## **Exhibit 9: Richard Rodgers Theater**

### **Exhibit 9B: Architectural Modifications**

**Exh. 9B Architectural Modifications to Rodgers Theater**

## 9. RICHARD RODGERS THEATER LOBBY- ACCESSIBLE TOILET ROOM / BOX OFFICE PLANS

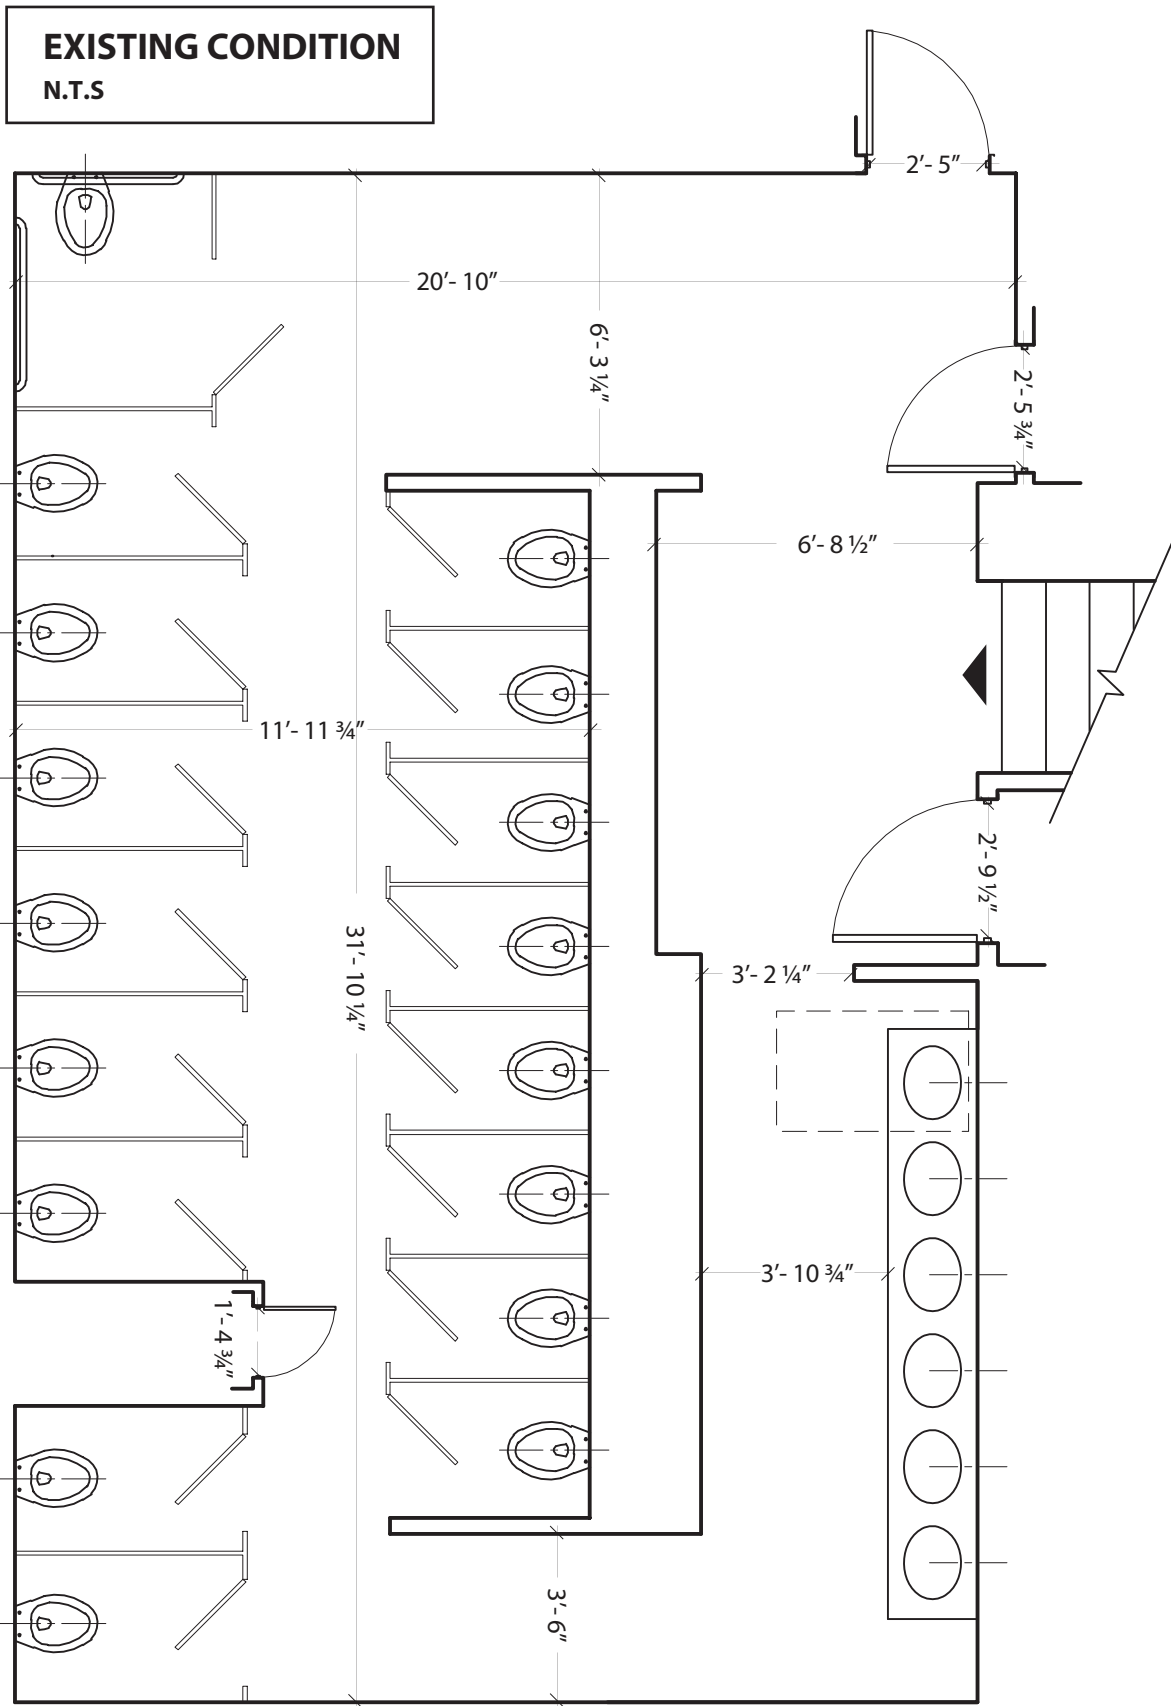
| <b>Line #</b> | <b>Location Description</b>    | <b>Existing Condition</b>   | <b>Barrier Removal</b>  | <b>1991 Standards Reference</b>   | <b>Architectural Modification</b>   |
|---------------|--------------------------------|---|---|---|---|
| 13            | Lobby (Accessible Toilet Room) | The mirror is mounted at 45" AFF to the bottom of the reflecting surface.   | Bottom of mirror reflecting surface is greater than 40" above finish floor.   | 4.1.3(11)<br>4.19.6<br>4.22.6<br>Fig. 31  | <b>Defendant has provided tilted mirror.</b>  |
| 14            | Lobby (Accessible Toilet Room) | The accessible toilet room is 77" x 44" with a raised alcove 19.5" deep and 17.5" wide that contains the inaccessible lavatory.                               | Existing small toilet room does not provide the required turning space, clear floor space at fixtures, or an accessible lavatory. | 4.1.3(11)<br>4.2.3<br>4.13<br>4.16<br>4.19<br>4.22<br>4.26<br>4.27<br>Fig. 3<br>Fig.28<br>Fig.29 etc. | <b>Defendant will provide automatic door for maneuvering clearance.</b>                 |
| 15            | Lobby (Accessible Toilet Room) | The side grab bar extends from 9" to 45" from the rear wall.  | Toilet room side grab bar is less than 42" long and extends to less than 54" from rear wall.                                      | 4.1.3(11)<br>4.16.4<br>4.22.4<br>4.26<br>Fig. 29  | <b>Defendant will provide compliant side grab bar to the extent readily achievable.</b> |
| 16            | Lobby (Accessible Toilet Room) | The water closet is approximately centered within the 44" wide space.   | The centerline of the water closet is greater than 18" from the side wall.  | 4.1.3(11)<br>4.16<br>4.22.4<br>Fig. 28  | <b>Defendant will provide compliant water closet location.</b>                          |
| 17            | Lobby (Accessible Toilet Room) | There is incised letter and Braille signage on the face of the outswinging door where a user within 3" of sign may be struck by an unexpectedly opening door. | There is no raised lettering and Braille room identification sign provided at this unisex single user toilet room.                | 4.1.3(16)(a)<br>4.30.1<br>4.30.4<br>4.30.5<br>4.30.6  | <b>Defendant will provide compliant signage.</b>  |
| 18            | Lobby (Accessible Toilet Room) | The toilet paper dispenser is mounted 31.5" to the near edge from the rear wall and 41.5" to the far edge from the rear wall.                                 | Double roll toilet paper dispenser is mounted with far roll more than 36" from back wall to far edge of paper roll.               | 4.1.3(11)<br>4.16.6<br>4.22.4<br>Fig.29(b)<br>Fig.30(d)   | <b>Defendant will provide accessible mounting height of toilet paper dispenser.</b>     |

| <b>Line #</b> | <b>Location Description</b>     | <b>Existing Condition</b>  | <b>Barrier Removal</b>  | <b>1991 Standards Reference</b>   | <b>Architectural Modification</b>                                |
|---------------|---------------------------------|--|---|---|--|
| 19            | Lobby (Accessible Toilet Room)  | Throw-bolt hardware on the door is at 59" AFF.   | Existing high door hardware cannot be grasped easily with one hand or requires tight grasping, pinching, or twisting of the wrist to operate. | 4.1.3(11)<br>4.13.9<br>4.22.2   | <b>Defendant will provide compliant hardware.</b>                |

Nederlander shall make the architectural modifications set forth in Exhibits 9A and 9B. In addition, Nederlander shall maintain the wheelchair accessible unisex restroom in the same condition as it existed for the Government's inspection conducted on May 3, 2011, as further modified in Exhibit 9B, and shall also (i) install a visual alarm in the restroom; (ii) install an automatic door for the restroom; and (iii) modify the location of the sink to provide an adequate maneuvering space as required by Standards § 4.16.2.

## 9. RICHARD RODGERS THEATER LOWER LEVEL - WOMEN'S TOILET ROOM PLAN

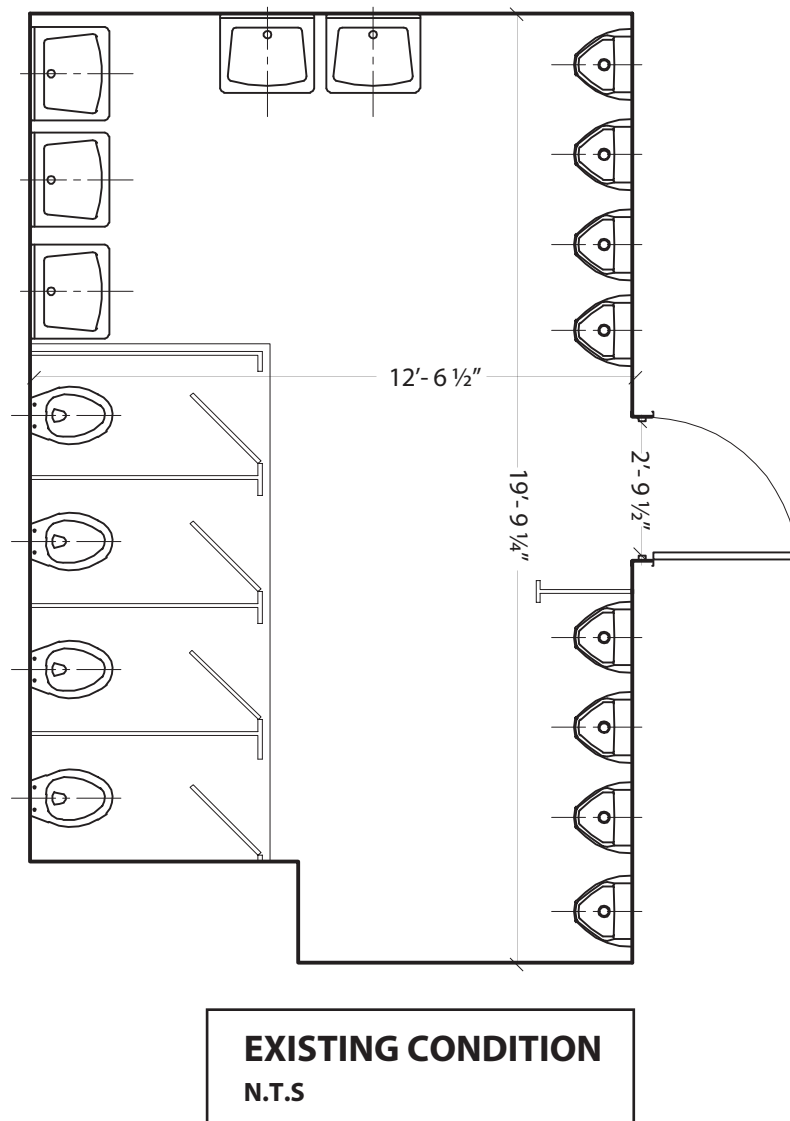
| <b>Line #</b> | <b>Location Description</b>       | <b>Existing Condition</b>  | <b>Barrier Removal</b>  | <b>1991 Standards Reference</b>                                 | <b>Architectural Modification</b>   |
|---------------|-----------------------------------|--|---|---|---|
| 31            | Lower Level (Women's Toilet Room) | Lower level is not served by an elevator or any other accessible route. There is also 1 step without handrails up from the lower level lobby into the women's toilet room. | Toilet room is on a level not served by an accessible route.  | 4.1.3(5)<br>4.1.6(1)(b)<br>4.1.6(2)<br>4.3.2(3)<br>4.3.8        | <b>Alterations to introduce vertical accessible route are not feasible due to structural constraints and landmarks status designation. Compliant handrails will be installed.</b> |

| <b>Line #</b> | <b>Location Description</b>          | <b>Existing Condition</b>   | <b>Barrier Removal</b>  | <b>1991 Standards Reference</b>                           | <b>Architectural Modification</b>  |
|---------------|--------------------------------------|---|---|---|--|
| 32            | Lower Level<br>(Women's Toilet Room) | The mirror is mounted at 44" AFF to the bottom of the reflecting surface.   | Bottom of mirror reflecting surface is greater than 40" above finish floor.   | 4.1.3(11)<br>4.19.6<br>4.22.6<br>Fig. 31                  | <b>Defendant will provide accessible mirror.</b>   |
| 33            | Lower Level<br>(Women's Toilet Room) | Approach to the water cooler in the corner of this toilet room lounge is blocked by stored water bottles which place controls out of reach. | Forward approach to water cooler is blocked in a narrow alcove by stored water bottles which place controls out of reach.                             | 4.1.3(10)<br>4.15<br>Fig. 27                              | <b>Defendant has provided accessible drinking fountain.</b>  |
| 34            | Lower Level<br>(Women's Toilet Room) | The public pay telephone is 65" AFF to the highest operable part (the coin slot) and offers no volume control.                              | Public pay phone is mounted too high and has no volume control (required on all accessible phones plus 25% of all other telephones of the same type). | 4.1.3(17)<br>4.2.5<br>4.2.6<br>4.30.7<br>4.31.3<br>Fig.44 | <b>Defendant has removed public pay telephone.</b>   |
| 35            | Lower Level<br>(Women's Toilet Room) | There is no RLB sign for this toilet room.  | There is no raised lettering and Braille room identification sign provided at this gender specific multi- user toilet room.                           | 4.1.3(16)(a)<br>4.30.1<br>4.30.4<br>4.30.5<br>4.30.6      | <b>Defendant will remove compliant signage.</b>  |
| 36            | Lower Level<br>(Women's Toilet Room) | The paper towel dispensers are mounted at 56" AFF.  | Towel dispenser is mounted outside of reach range.  | 4.1.3(11)<br>4.2.4<br>4.2.5<br>4.2.6<br>4.22.7            | <b>Defendant has relocated towel dispenser to accessible mounting height during course of investigation.</b> |
| 37            | Lower Level<br>(Women's Toilet Room) | There are 2 wall mounted lavatories with a rim height of 32" AFF and knee space of 28" AFF at the front edge.                               | Wall-mounted lavatories all have less than required knee clearance (29" minimum AFF at front, 27" minimum AFF at 8" deep).                            | 4.1.3(11)<br>4.19.2<br>4.19.3<br>4.22.6<br>Fig. 31        | <b>Defendant will modify existing lavatories for knee clearance compliance.</b>                              |

**9. RICHARD RODGERS THEATER**  
**LOWER LEVEL - MEN'S TOILET ROOM PLAN**

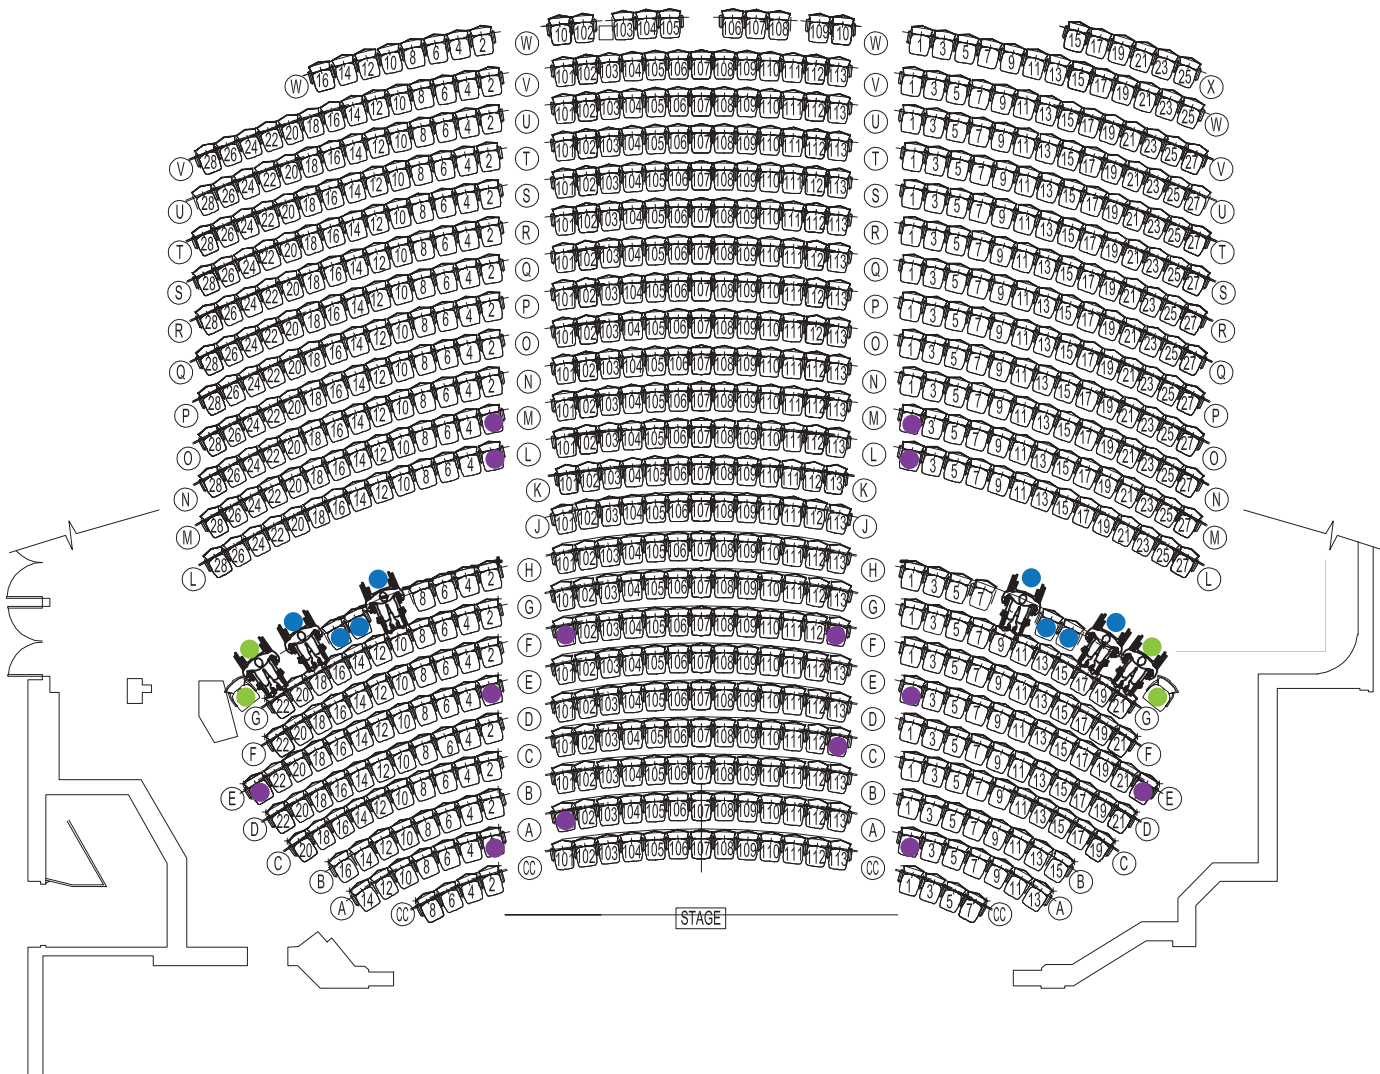
| <b>Line #</b> | <b>Location Description</b>     | <b>Existing Condition</b>  | <b>Barrier Removal</b>  | <b>1991 Standards Reference</b>   | <b>Architectural Modification</b>                                |
|---------------|---------------------------------|--|---|---|--|
| 20            | Lower Level (Men's Toilet Room) | Lower level is not served by an elevator or any other accessible route. There are also 2 steps without handrails up from the lower level lobby into the men's toilet room. | Toilet room is on a level not served by an accessible route.  | 4.1.3(1)<br>4.1.3(3)<br>4.1.3(5)<br>4.1.6(1)(b)<br>4.1.6(2)<br>4.3.2(3)<br>4.3.8<br>4.5.2 | <b>Defendant has provided compliant handrail.</b>                |
| 21            | Lower Level (Men's Toilet Room) | The mirror is mounted at 53" AFF to the bottom of the reflecting surface.  | Bottom of mirror reflecting surface is greater than 40" above finish floor.   | 4.1.3(11)<br>4.19.6<br>4.22.6<br>Fig. 31  | <b>Defendant will provide compliant mirror.</b>                  |
| 22            | Lower Level (Men's Toilet Room) | There are 4 toilet stalls in this toilet room with a 4" step up into each stall, none of which are accessible.   | Vertical change in level is more than ¼" high.  | 4.1.3(1)<br>4.1.3(3)<br>4.3.8<br>4.5.2<br>Fig. 7(a-b)                                     | <b>Defendant will adjust vertical change in level.</b>           |
| 23            | Lower Level (Men's Toilet Room) | There is only 7" width on the pull side door maneuvering clearance and 2 steps without a landing on the push side.   | Maneuvering clearances at doorway are less than required.   | 4.1.3(1)<br>4.1.3(3)<br>4.3.8<br>4.5.2<br>4.13.6<br>Fig. 25(a-f)                          | <b>Defendant will increase maneuvering clearance.</b>            |
| 24            | Lower Level (Men's Toilet Room) | High, standard drinking fountain in 34" wide alcove is not accessible to wheelchair users, little people, and those with restricted reach.                                 | Forward approach, standup drinking fountain is installed in a narrow alcove >24" deep and < 36" wide.   | 4.1.3(10)<br>4.15<br>Fig. 27  | <b>Defendant will renovate drinking fountain for compliance.</b> |

| <b>Line #</b> | <b>Location Description</b>       | <b>Existing Condition</b>  | <b>Barrier Removal</b>  | <b>1991 Standards Reference</b>                                 | <b>Architectural Modification</b>   |
|---------------|-----------------------------------|--|---|---|---|
| 25            | Lower Level (Men's Toilet Room)   | The public pay telephone is 63.5" AFF to the highest operable part (the coin slot) and offers no volume control.   | Public pay phone is mounted too high and has no volume control (required on all accessible phones plus 25% of all other telephones of the same type). | 4.1.3(17)<br>4.2.5<br>4.2.6<br>4.30.7<br>4.31.3<br>Fig.44       | <b>Defendant will remove public pay telephone.</b>  |
| 26            | Lower Level (Men's Toilet Room)   | Sign is not RLB and is mounted high on the face of the door.   | There is no raised lettering and Braille room identification sign provided at this gender specific multi- user toilet room.                           | 4.1.3(16)(a)<br>4.30.1<br>4.30.4<br>4.30.5<br>4.30.6            | <b>Defendant will install compliant signage.</b>  |
| 27            | Lower Level (Men's Toilet Room)   | The paper towel dispensers are mounted at 55" AFF.   | Towel dispenser is mounted outside of reach range.  | 4.1.3(11)<br>4.2.4<br>4.2.5<br>4.2.6<br>4.22.7                  | <b>Defendant will remount towel dispenser.</b>  |
| 28            | Lower Level (Men's Toilet Room)   | There are 5 wall mounted lavatories with a rim height of 31" AFF, 27" AFF knee space at the front edge, and 23.5" AFF knee space at 8" back.                               | Wall-mounted lavatories all have less than required knee clearance (29" minimum AFF at front, 27" minimum AFF at 8" deep).                            | 4.1.3(11)<br>4.19.2<br>4.19.3<br>4.22.6<br>Fig. 31              | <b>Defendant will remount wall lavatories.</b>  |
| 29            | Lower Level (Men's Toilet Room)   | There are 8 urinals in this toilet room, none of which are accessible.   | Urinal(s) is(are) provided but there is not an accessible urinal.   | 4.1.3(11)<br>4.22.5<br>4.18.3                                   | <b>Defendant will install accessible urinal.</b>  |
| 30            | Lower Level (Men's Toilet Room)   | The door requires 9 pounds of force to open.   | Closer at non-fire-rated interior door exceeds the maximum force to open (5 lbs).   | 4.1.3(7)(b)<br>4.1.3(7)(c)<br>4.1.3(7)(d)<br>4.13.10<br>4.13.11 | <b>Defendant will test and maintain door closer for compliance.</b>   |

### **Exhibit 9C: Seating**

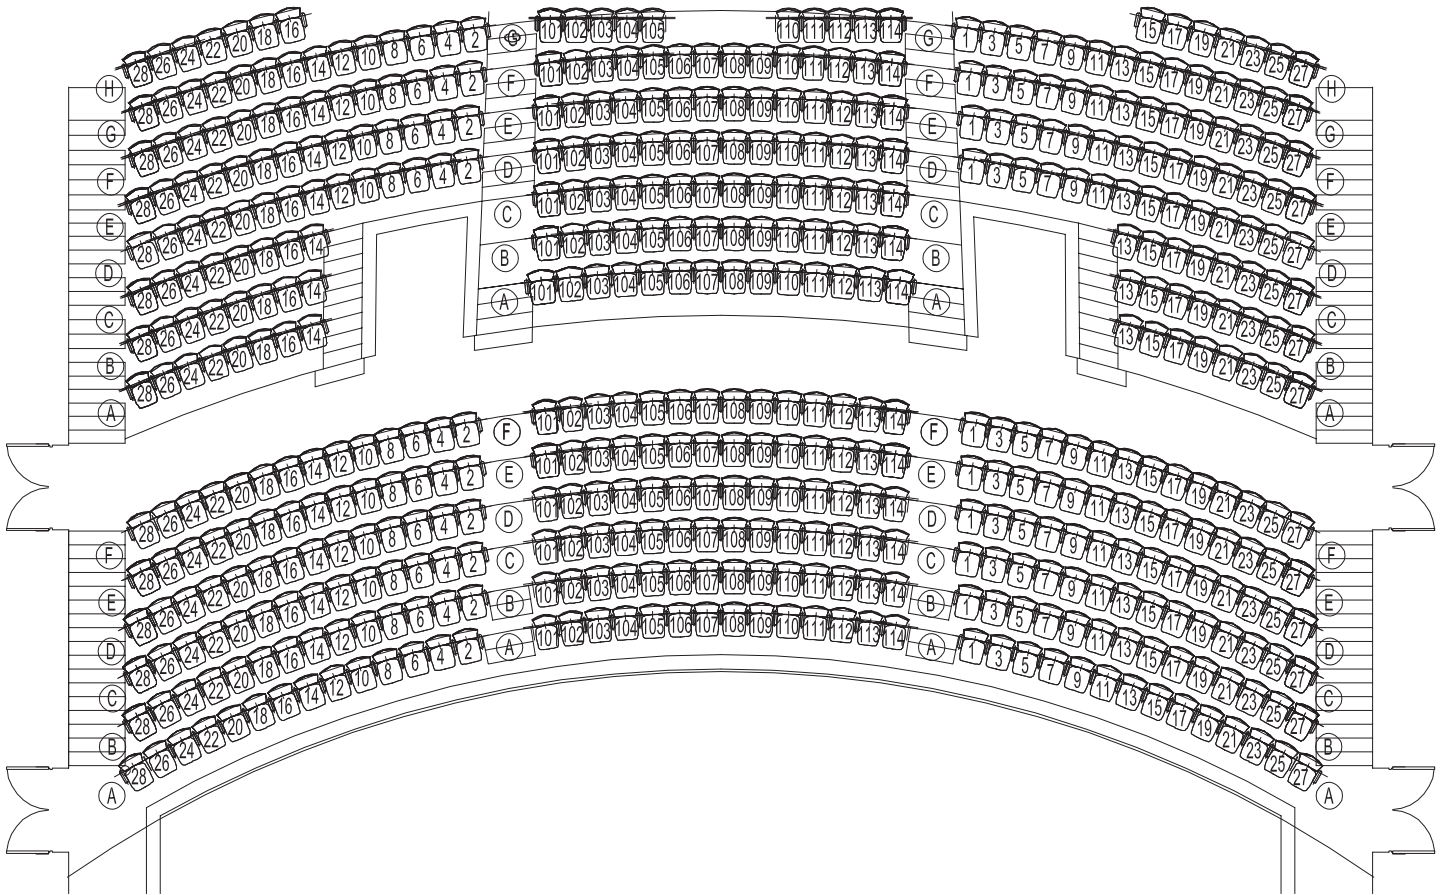
1. Nederlander shall maintain the two existing wheelchair and companion seating locations on the orchestra level: at H17, and H18, with H19 and H21 being companion seating locations.

2. Nederlander shall add four new wheelchair seating locations at H9, H15, H10, and H16, with H11, H13, H12, and H14 being companion seating locations.

3. Nederlander shall add fourteen new aisle transfer seating locations on Orchestra level at A1, A2, A101, C113, E1, E2, E23, E24, F101, F113, L1, L2, M1, and M2.
